RE: MIP-14-05/WAP-14-02
Resubmittal and Response to Letter of Incomplete dated June 24, 2014

**Application and Findings
for
a 3-Lot Partition
for
John DeCosta
CES #2946**

MAPLETON PARTITION
 CASE FILE NO.: MIP-14-05/WAP-14-02

PROJECT NO.: 2046
DESIGNED BY: ARW
DATE: 07/08/14
DRAWN BY: ARW
EXISTING CONDITIONS

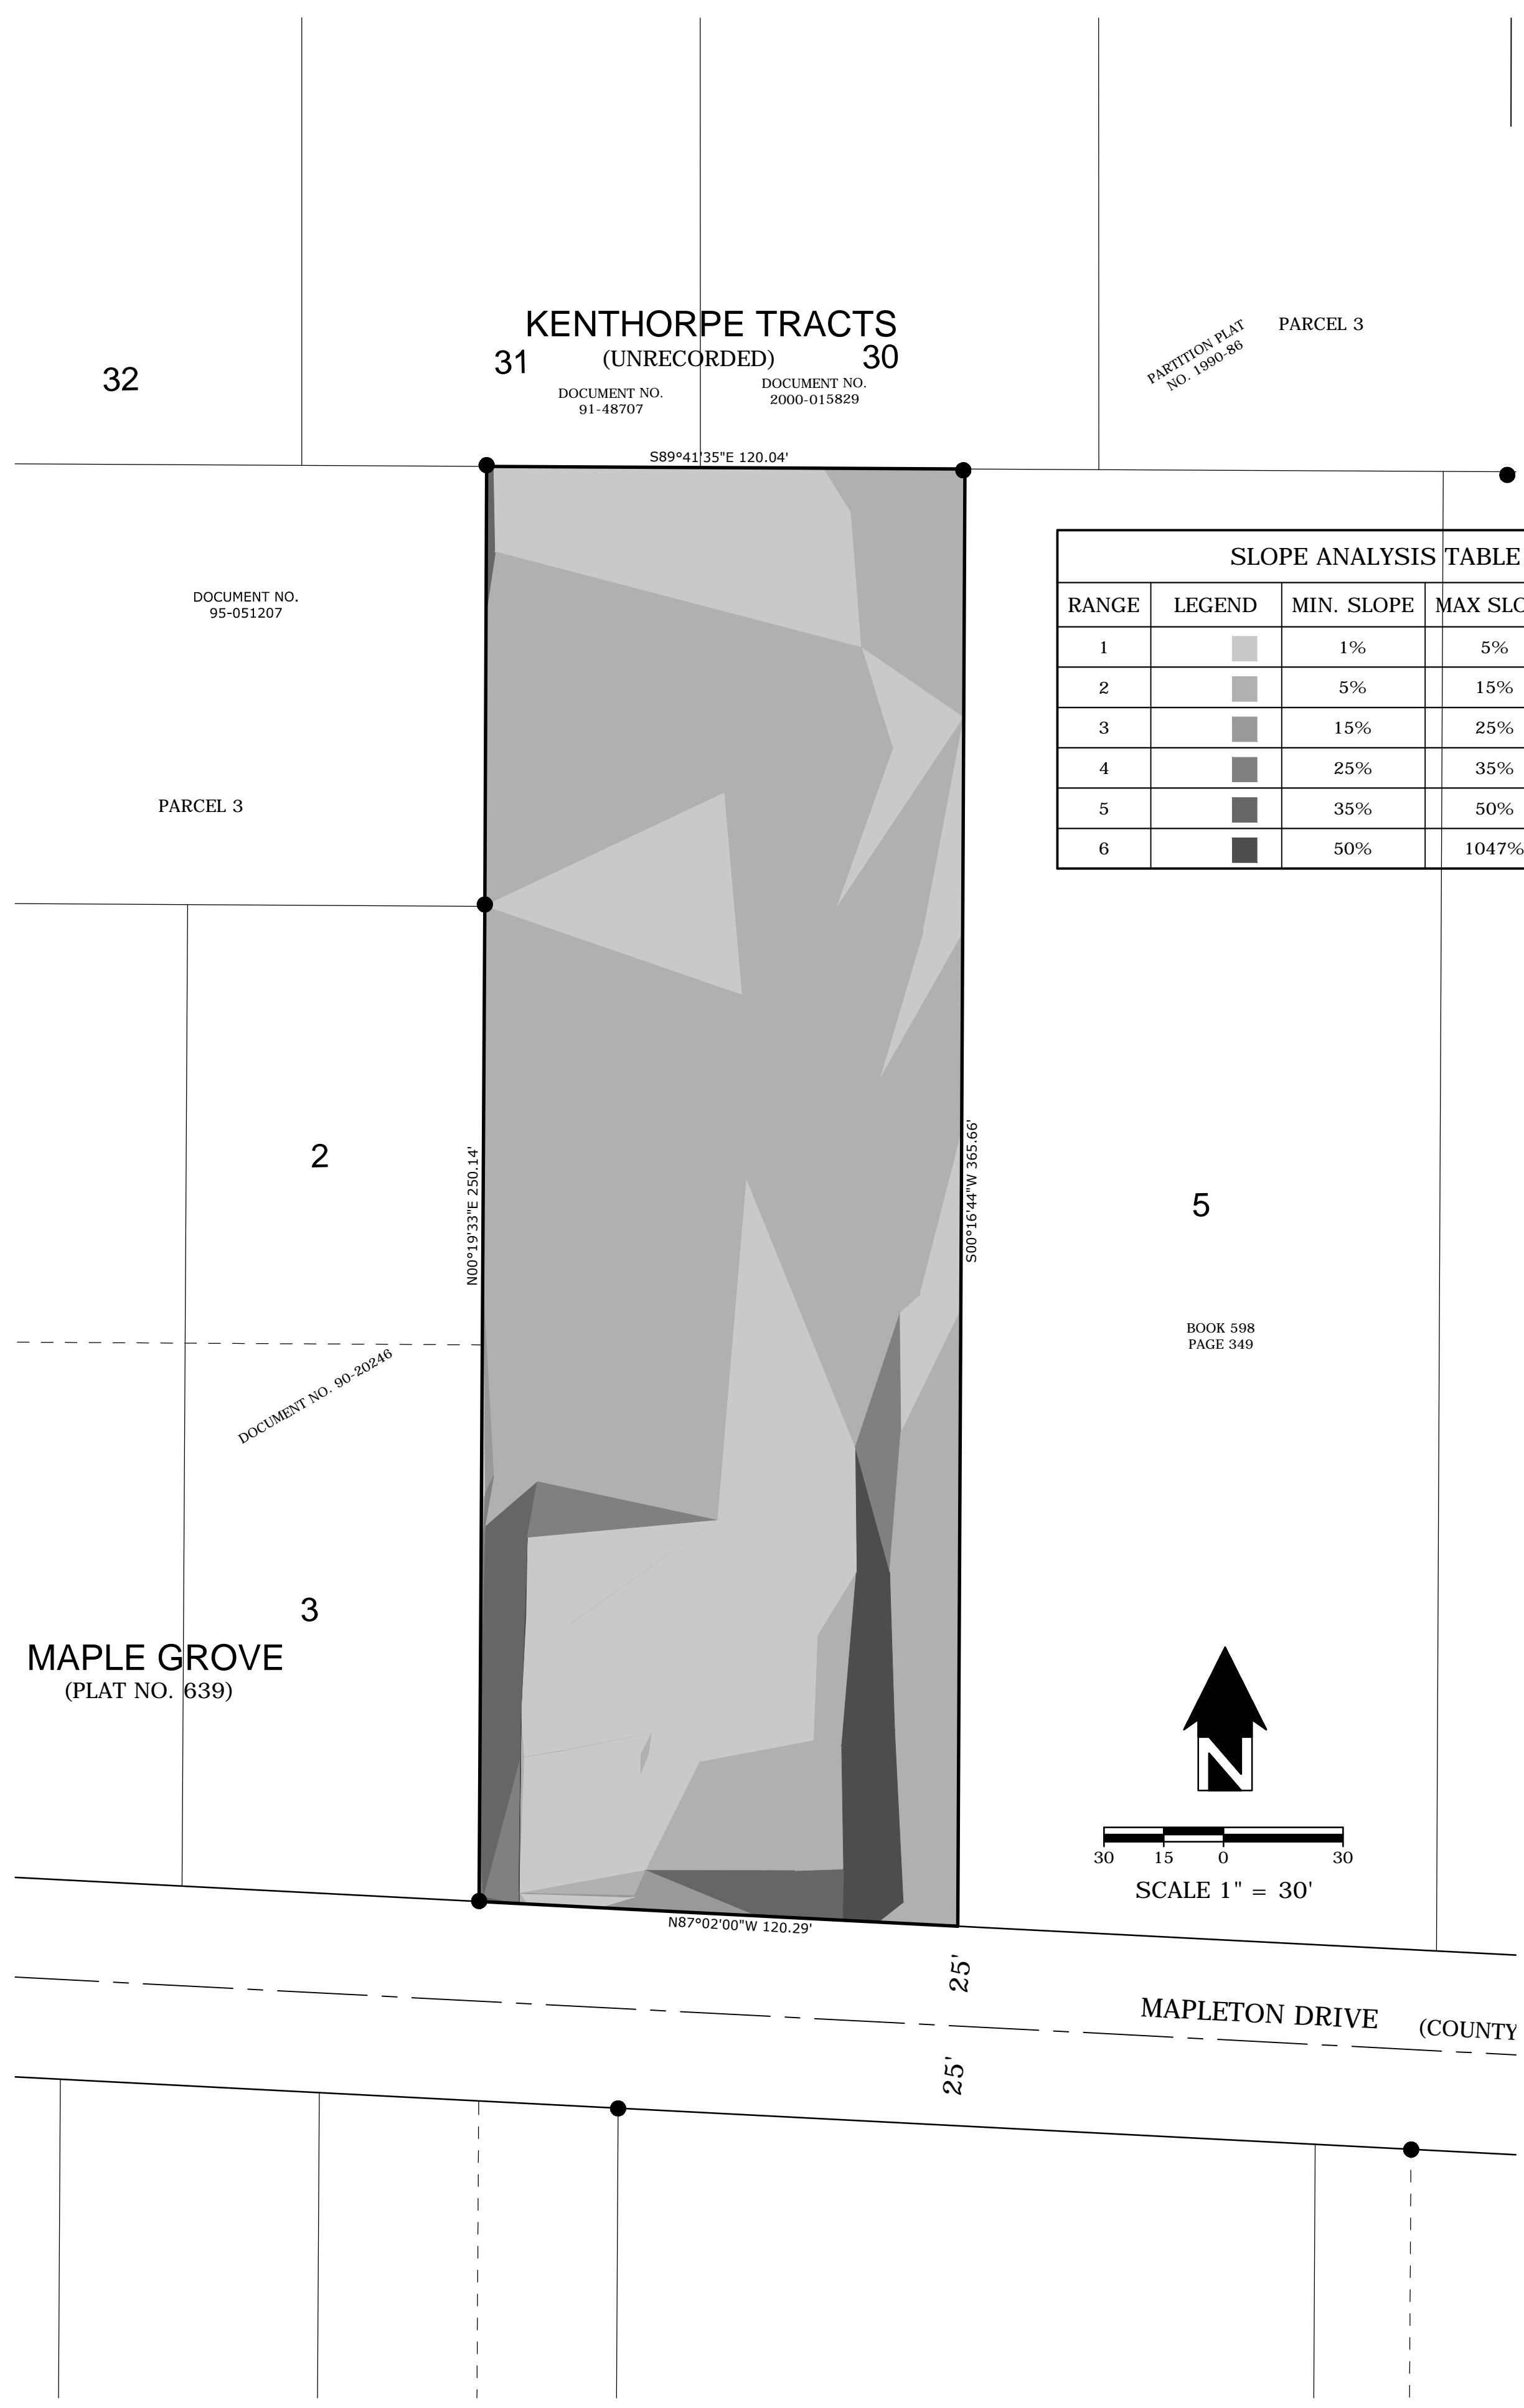
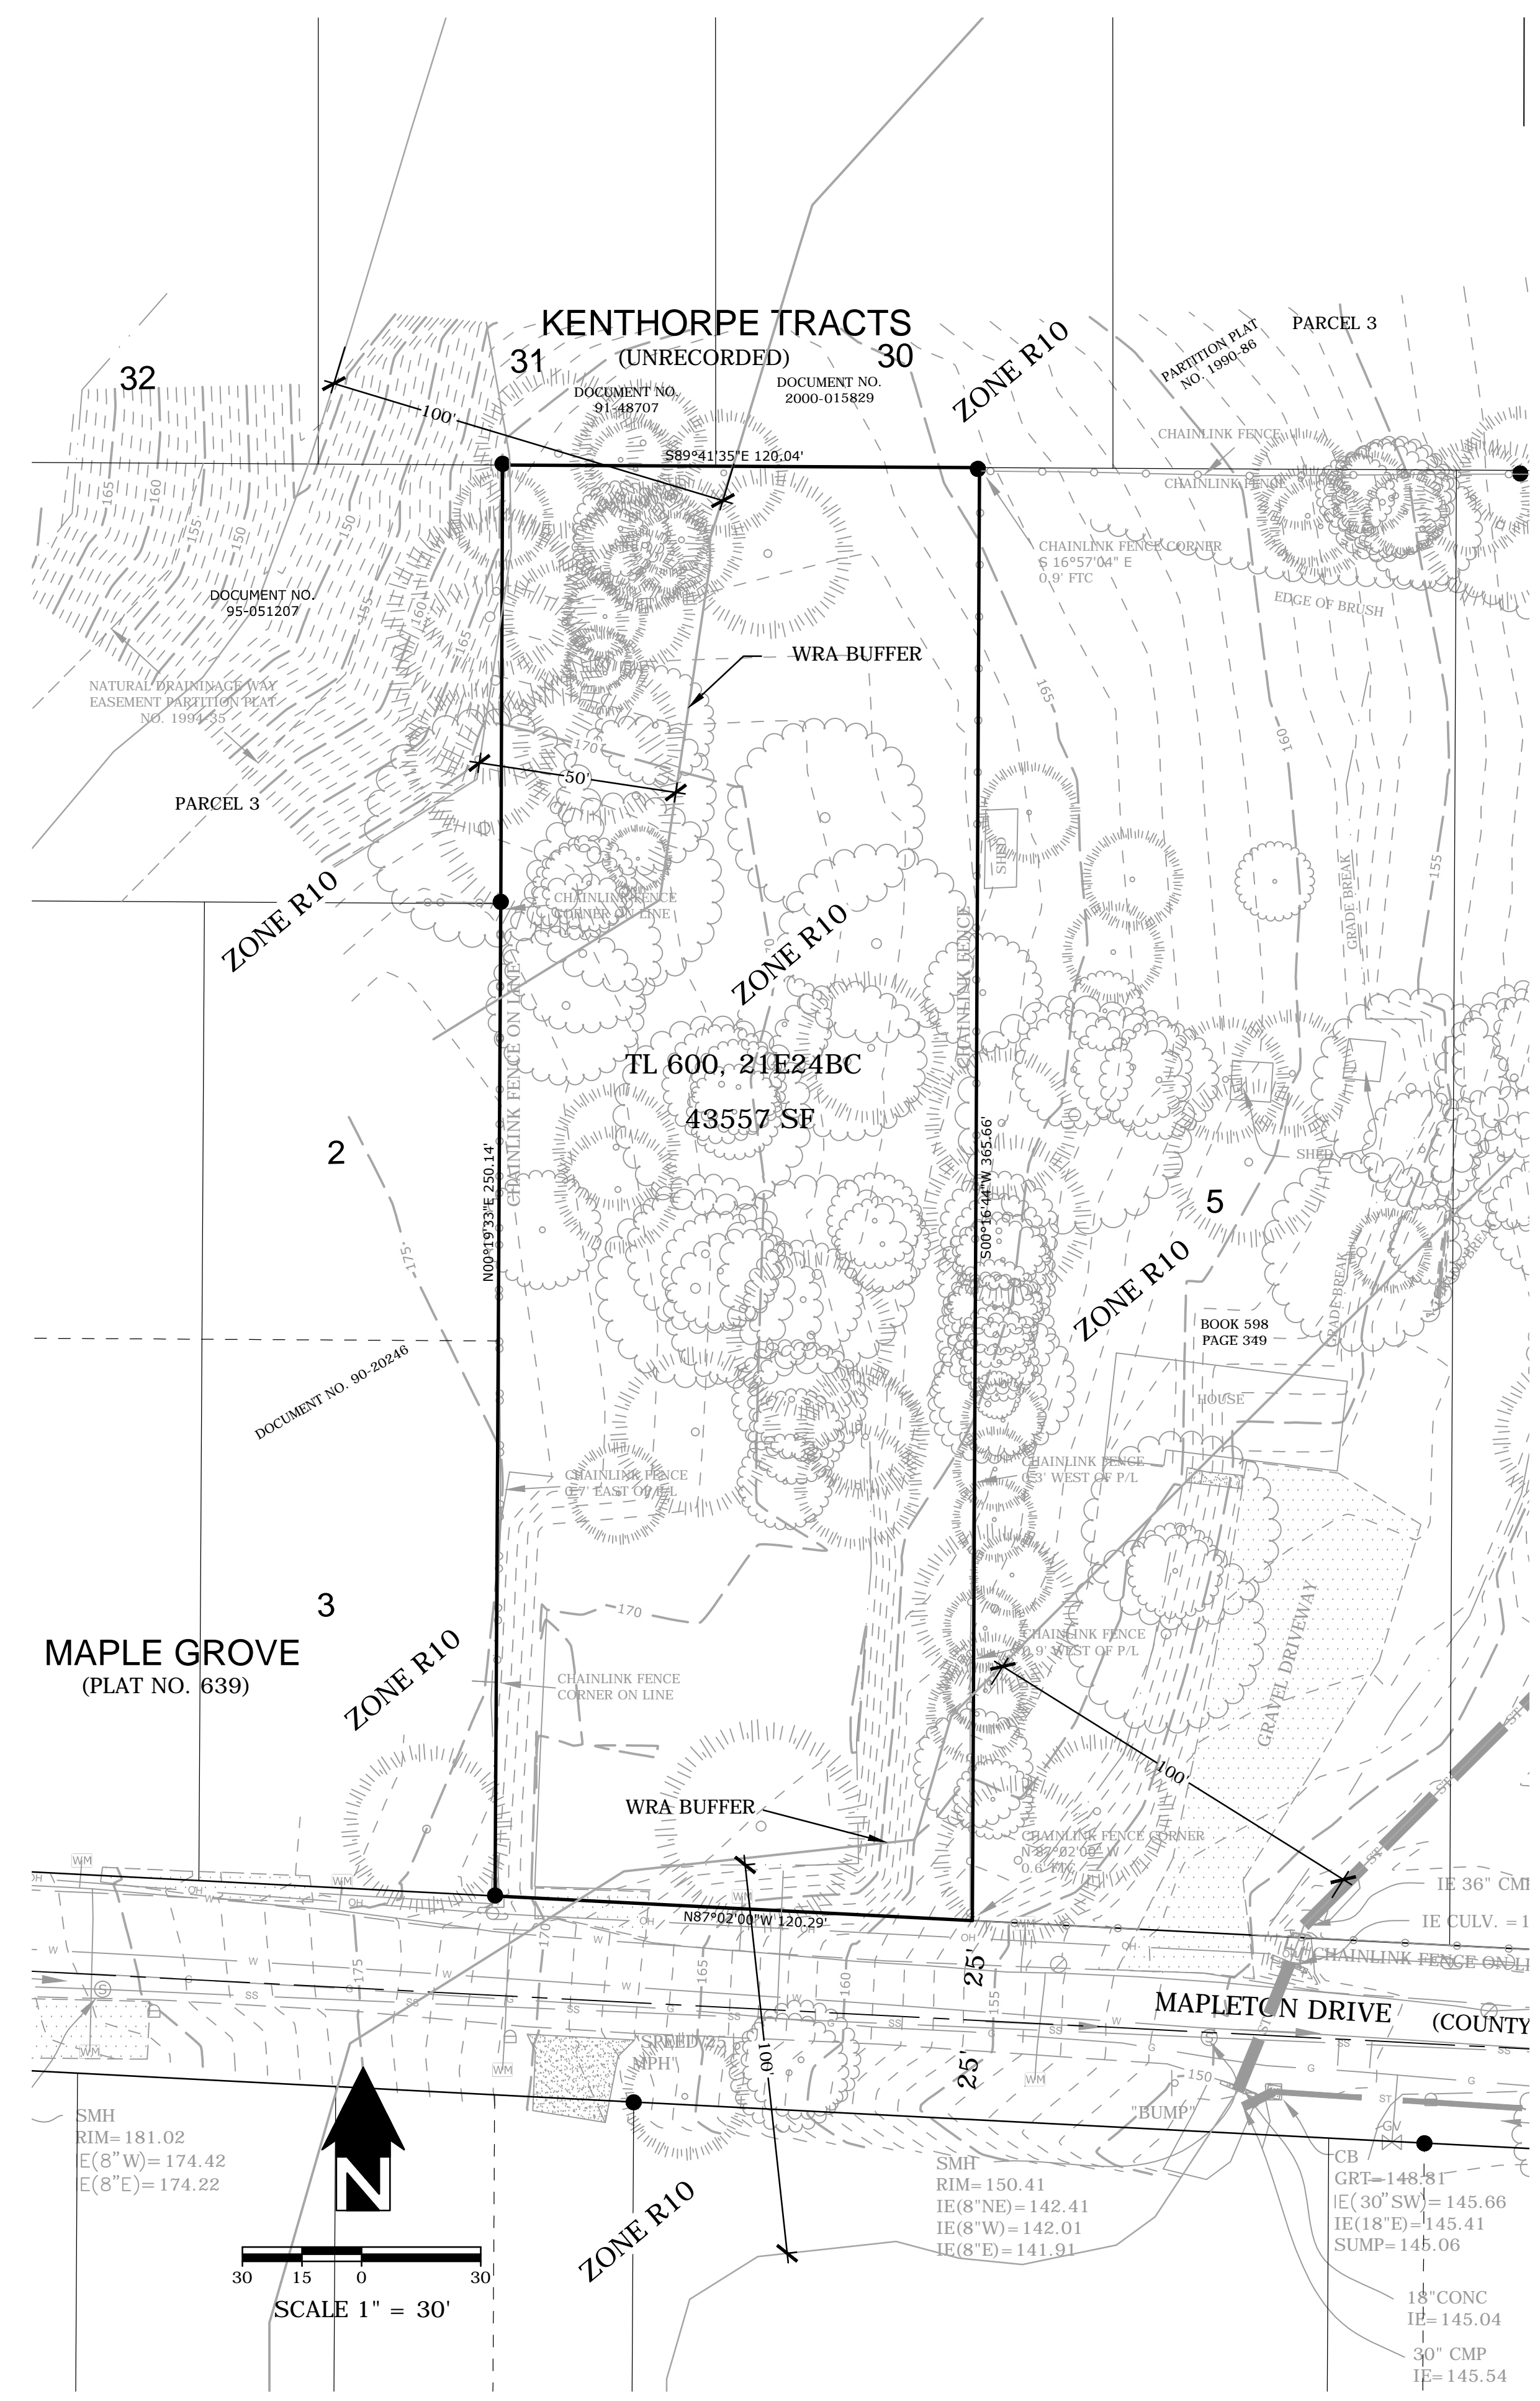
Section 85.160(E)(4): The watercourses have been added to the Preliminary Plat and the Tree Protection/Revegetation Plan in the drawing set, and continue to be shown on the Existing Conditions Plan as well.
